ADDENDUM NO. 02

DATE: April 29, 2020

PROJECT: Inglemoor High School Concert Hall + Music Building Project

SHEET C3.00 – Demolition Plan

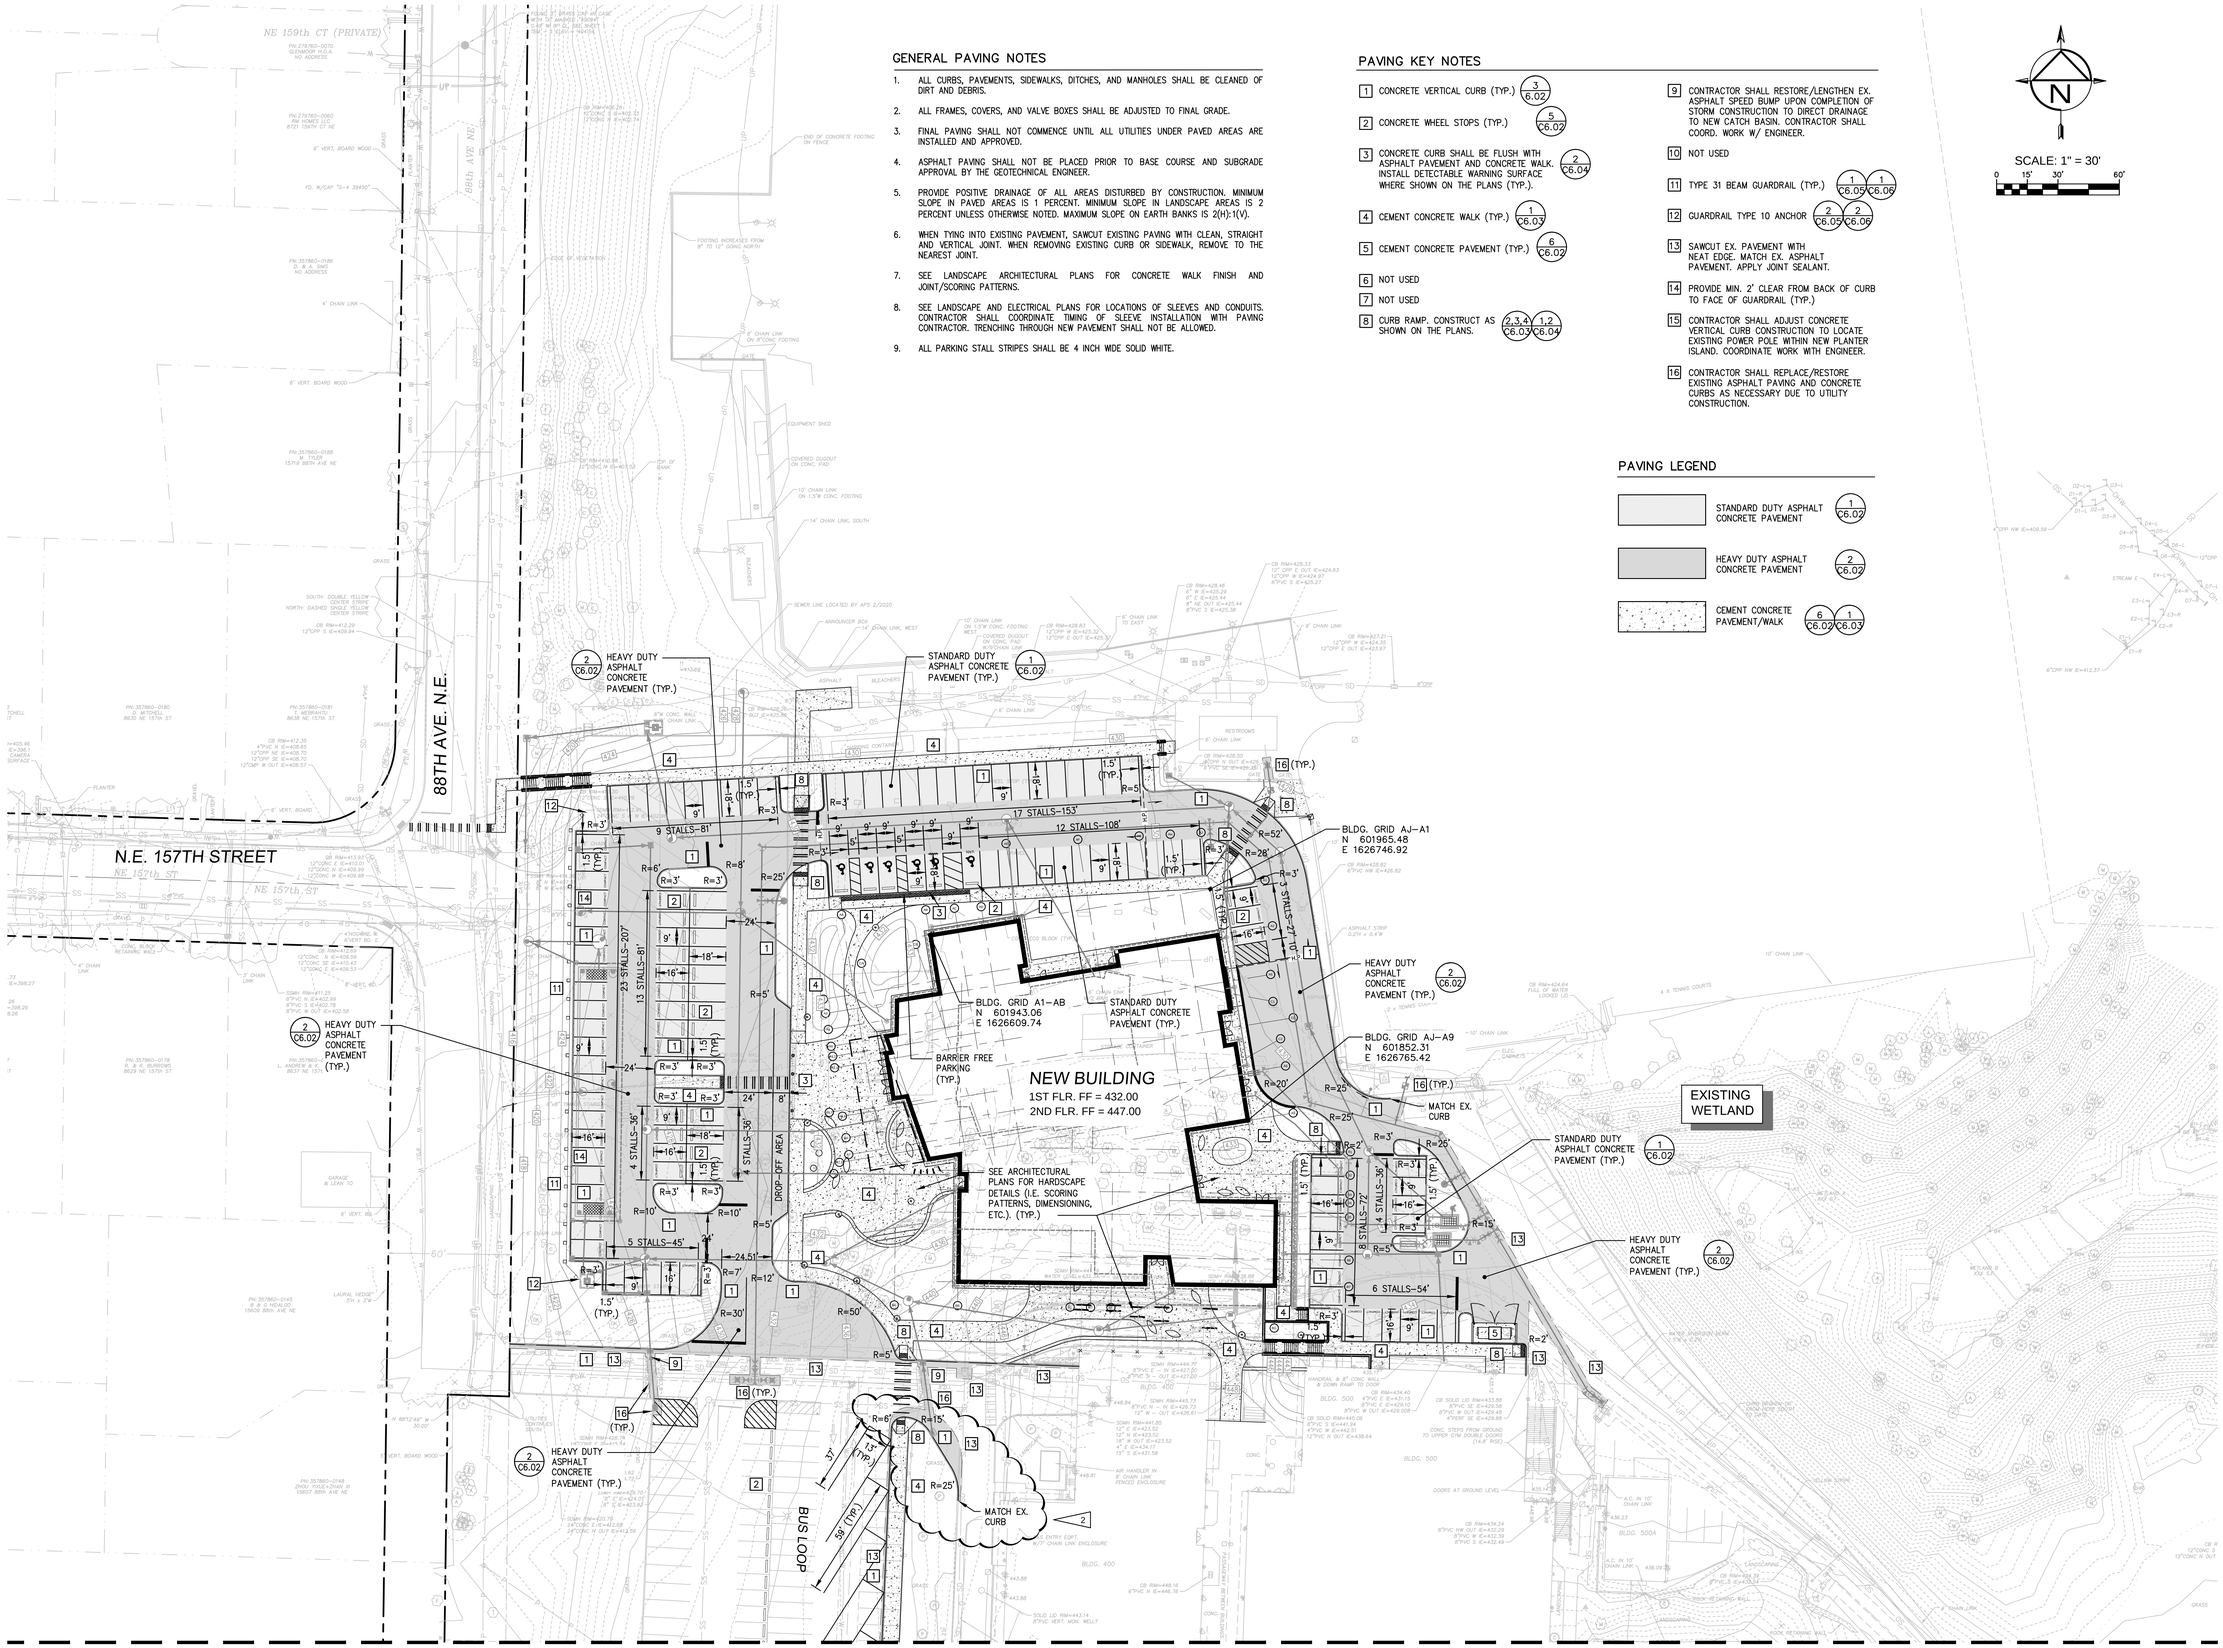
1. ADD "Remove existing curb and paving on south side of existing service drive. Clear and strip existing landscaped area on south side of existing service drive to receive new paving." per attachment C3.00.

26 ENLARGED SITE PLAN @ SGATE

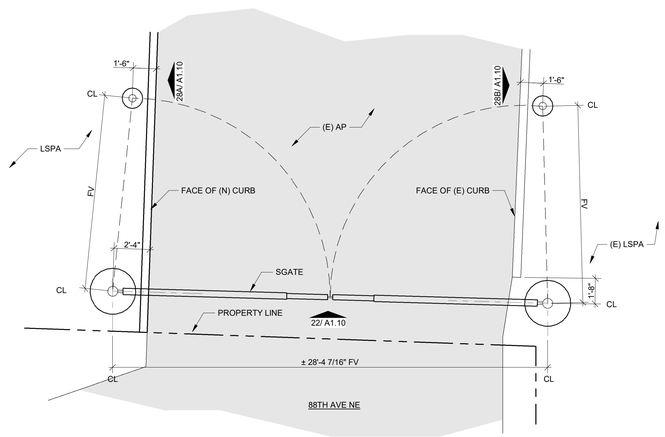
SHEET A1.10 – Partial Architectural Site Plan & Details
1. On Detail 25, REVISE per attachment A1.10

Architectural Foundation Details

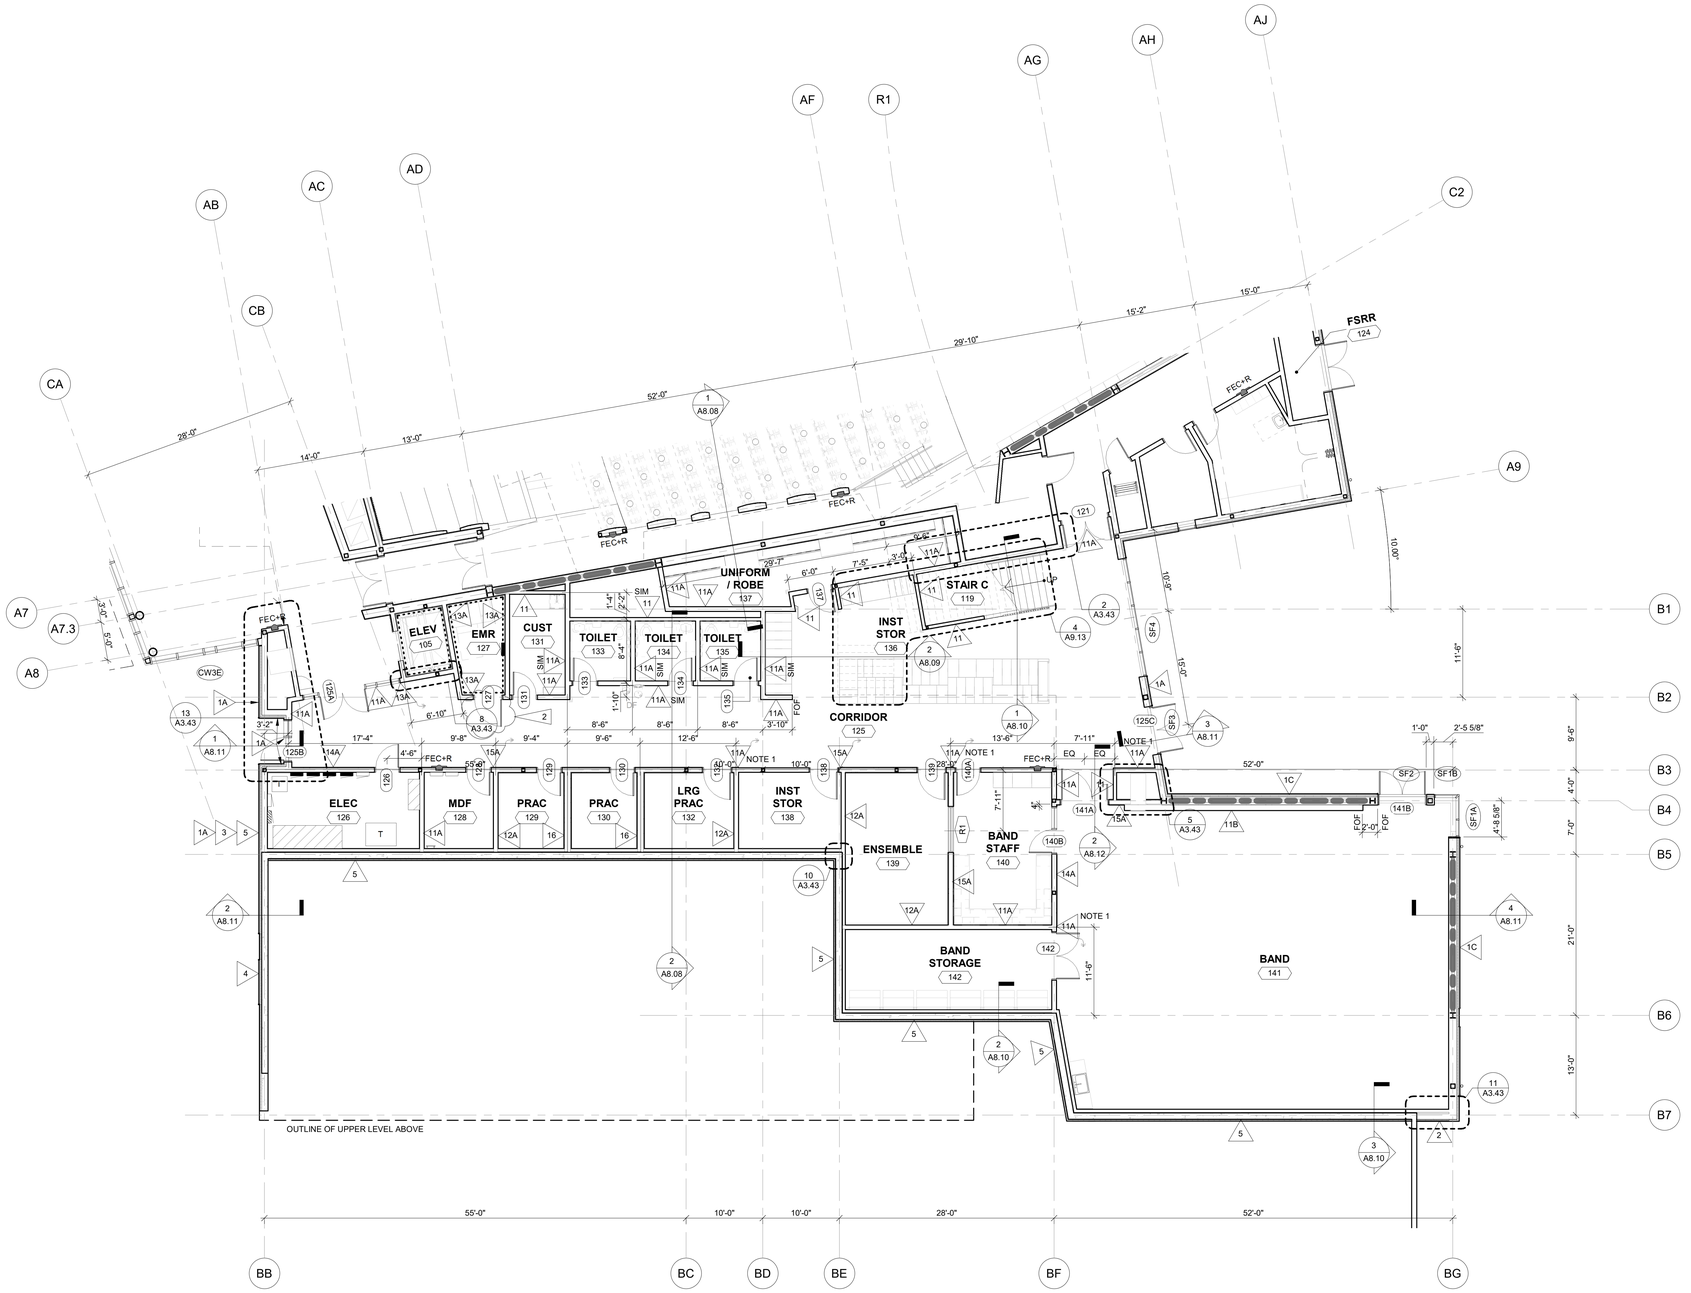
SHEET A2.40 – Architectural Foundation Details
1. On Detail 14 and Keylink Schedule, REVISE per attachment A2.40

Reflected Ceiling Plan Details - Area A - Concert Hall

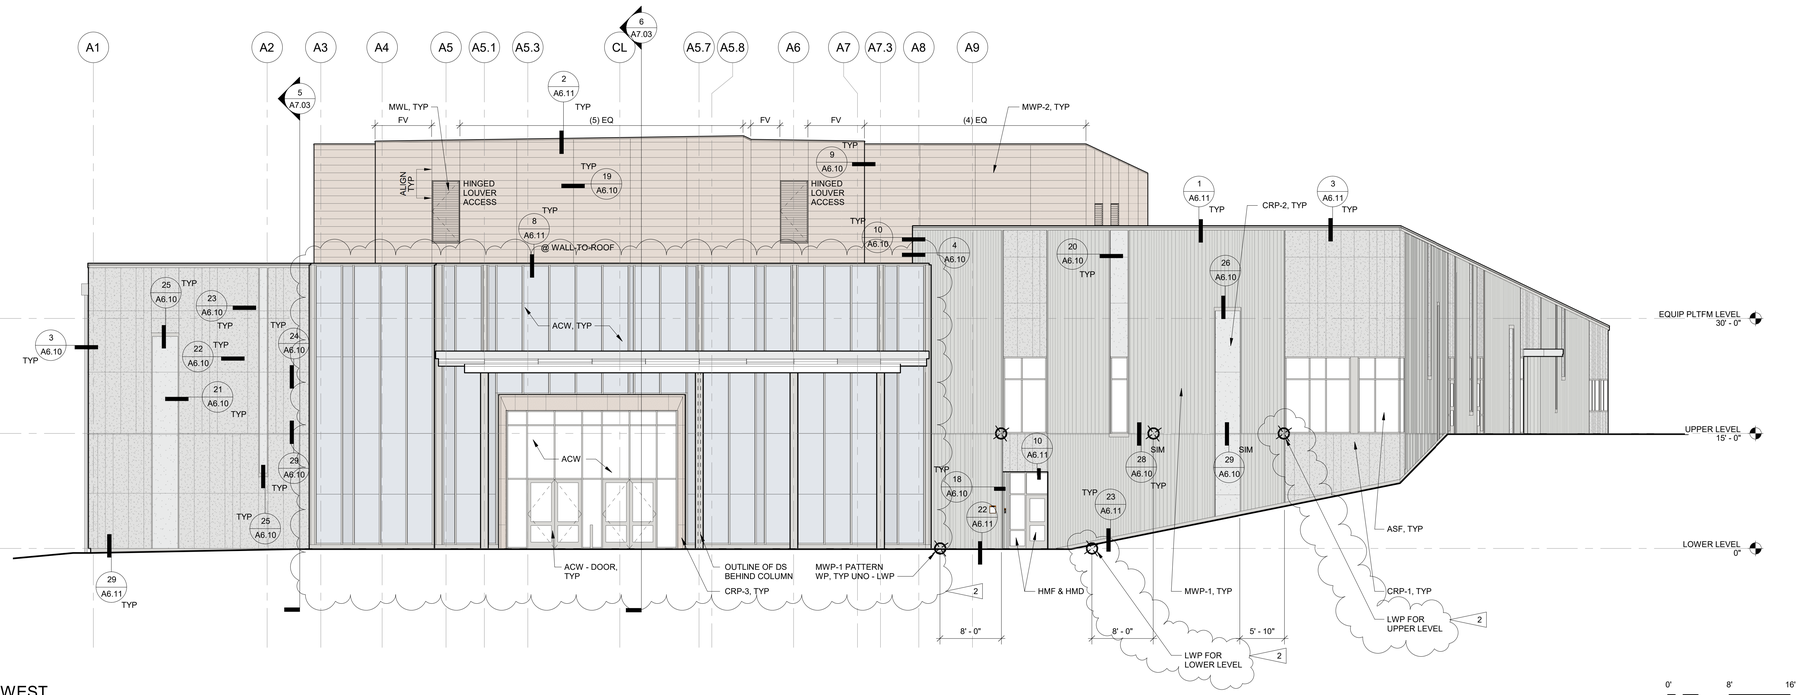
SHEET A5.43 – Reflected Ceiling Plan Details – Area A – Concert Hall
1. On Detail 1B, 1D, 1E, 2B, 5B, 5D and 8, REVISE per attachment A5.43
2. ADD General Notes to read: "1. REFER TO SHEE A4.51 FOR WAL FINISH DETAILS FOR PLASTIC LAMINATE WOOD PANEL (PLWP)."

1 EAST
SCALE: 1/8" = 1'-0"

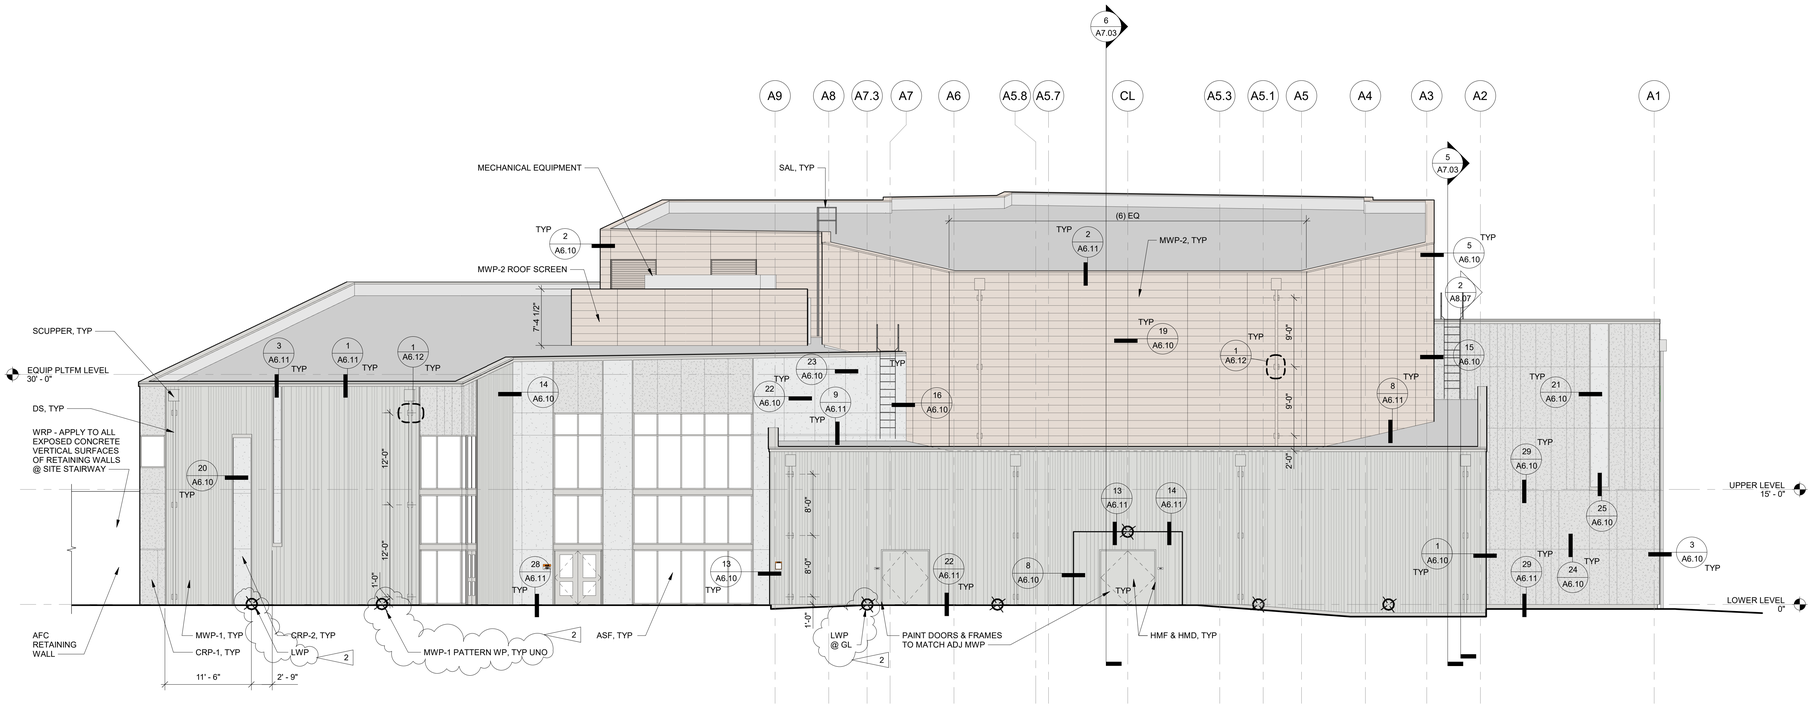
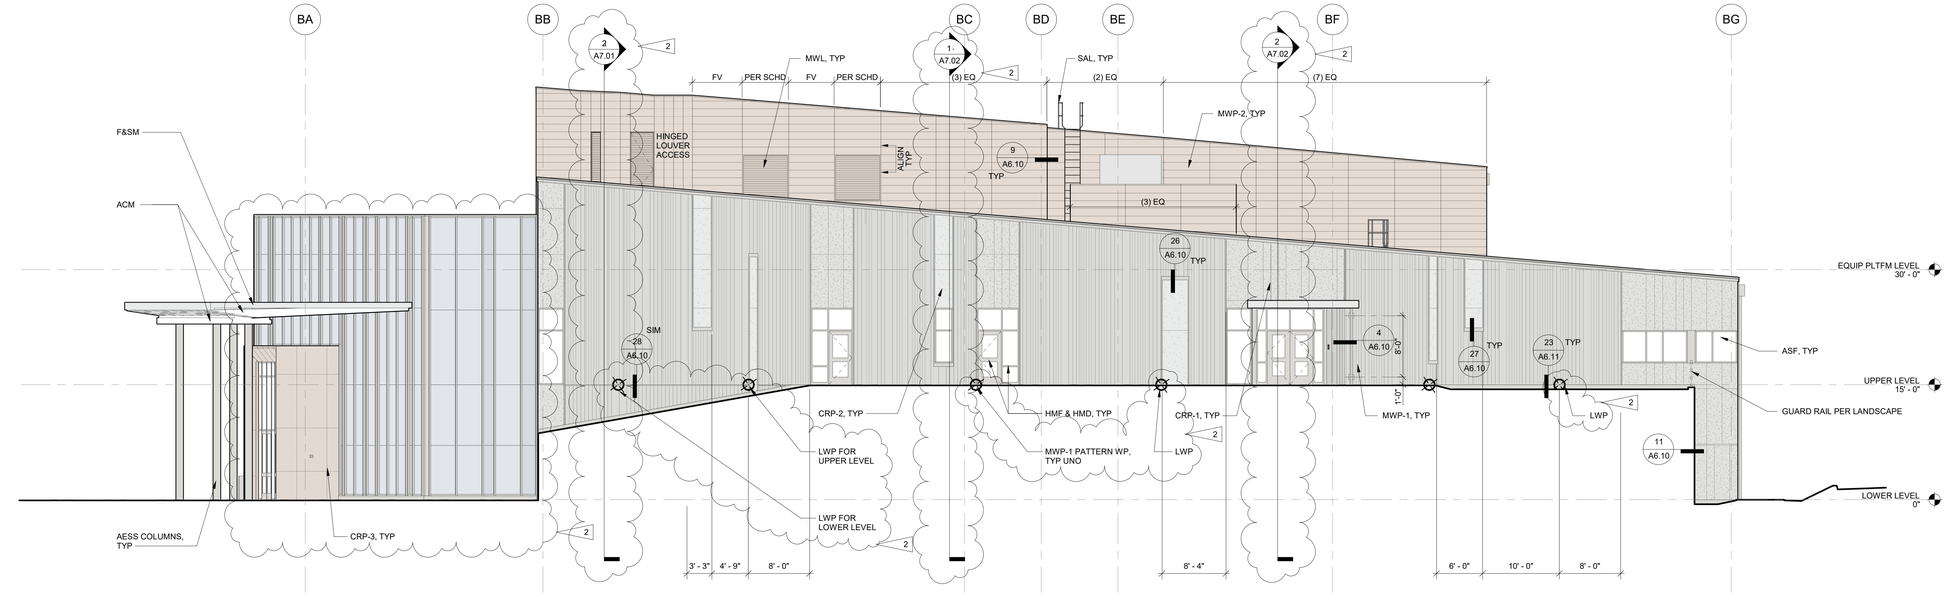
SHEET A6.01 – Exterior Elevations
1. On Details 1, 2, Exterior Material Legend, and Keylink Schedule, REVISE per attachment A6.01

Enlarged Restroom Plans, Elevations & Typical Details - Student Restrooms

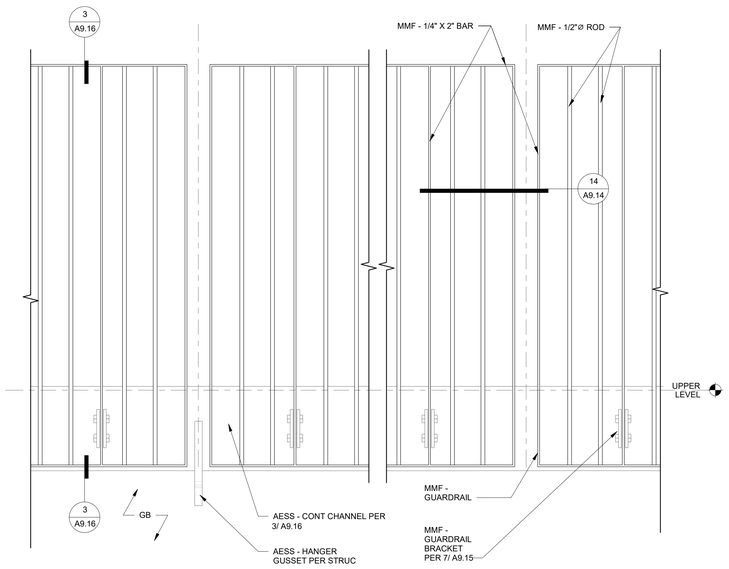
SHEET A9.01 – Enlarged Restroom Plans, Elevations & Typical Details – Student Restrooms
1. On Detail 1, 4, and 5, REVISE per attachment A9.01

Stair C Details

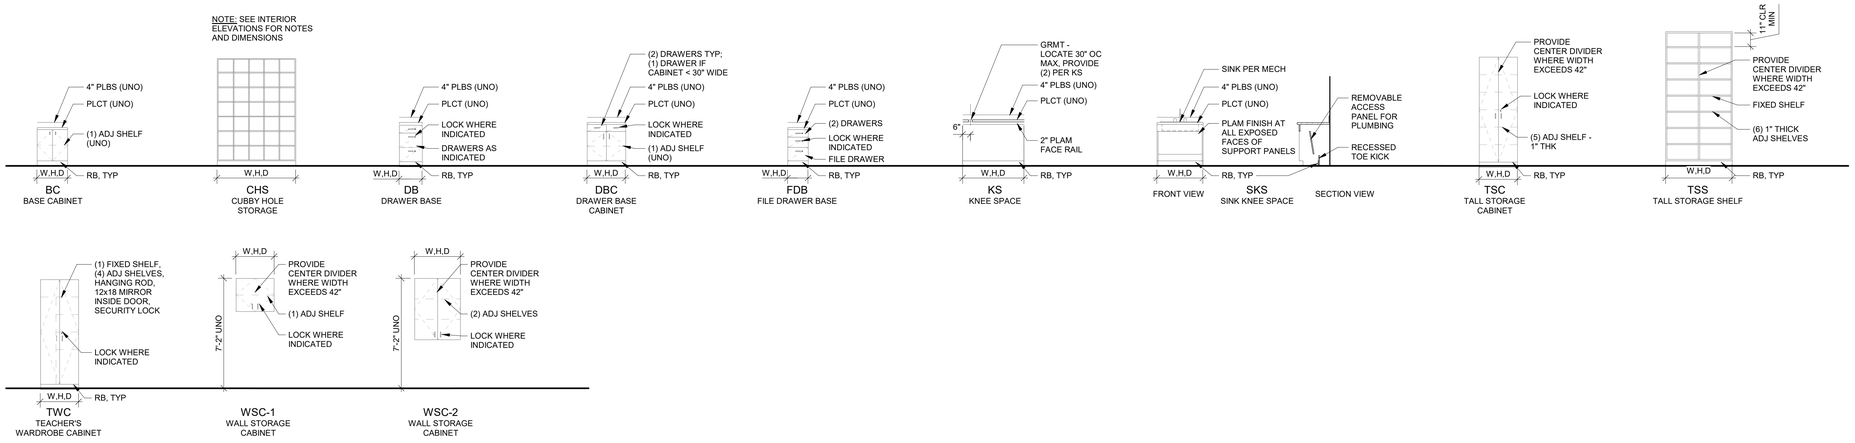
SHEET A9.16 – Stair C Details
1. On Detail 5, 10, and 11, REVISE per attachment A9.16

Enlarged Plans & Details

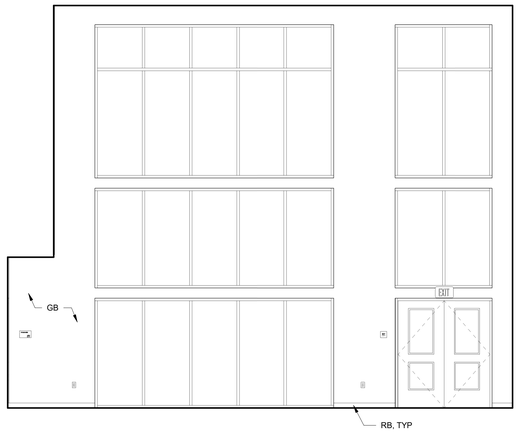
SHEET A10.02 – Enlarged Plans & Details
1. On Detail 6, REVISE per attachment A10.02
